BULLITT PARK SUBDIVISION

APPLICATION NUMBER 16 DATE May 6, 2004

REQUEST Subdivision

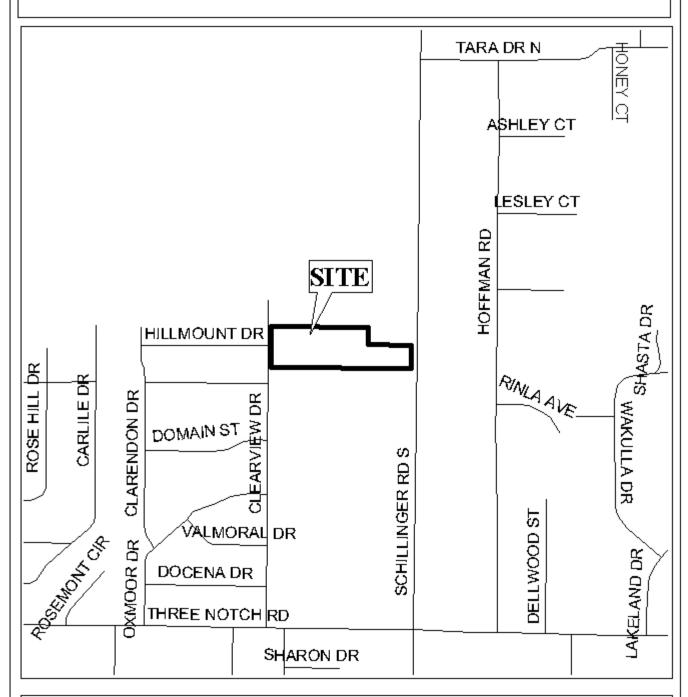
The plat illustrates the proposed 16 lot, $8.8 \pm$ acres subdivision which is located on the West side of Schillinger Road, 4/10 mile \pm North of Three Notch Road. The subdivision is served by public water and individual septic systems.

The purpose of this application is to create a sixteen-lot subdivision from a metes and bounds parcel. It should be noted that the excluded lot at the Northeast corner of the site is a nonconforming lot of record as it was created prior to the Subdivision Regulations applying to the Planning Jurisdiction.

The site fronts Schillinger Road, a planned major street, which has an existing right-of-way of 80 feet; the Major Street Plan requires a 100-foot right-of-way. Therefore, the dedication of any necessary right-of-way to provide 50-feet from the centerline of Schillinger Road, should be required. Additionally, as a means of access management, the placement of a note on the final plat stating that Lot 1 is denied direct access to Schillinger Road and Lot 9 is denied direct access to Clearview Drive, should be required.

This site is located in the County, thus a note should be placed on the final plat stating that any lots which are developed commercially and adjoin residentially developed property must provide a buffer, in compliance with Section V.A.7. of the Subdivision Regulations.

The plat meets the minimum requirements of the Subdivision Regulations and is recommended for Tentative Approval subject to the following conditions: 1) the dedication of adequate right-of-way to provide 50-feet from the centerline of Schillinger Road; 2) the placement of a note on the final plat stating that Lot 1 is denied direct access to Schillinger Road and Lot 9 is denied direct access to Clearview Drive; and 3) the placement of a note on the final plat stating that any lots which are developed commercially and adjoin residentially developed property must provide a buffer, in compliance with Section V.A.7. of the Subdivision Regulations.
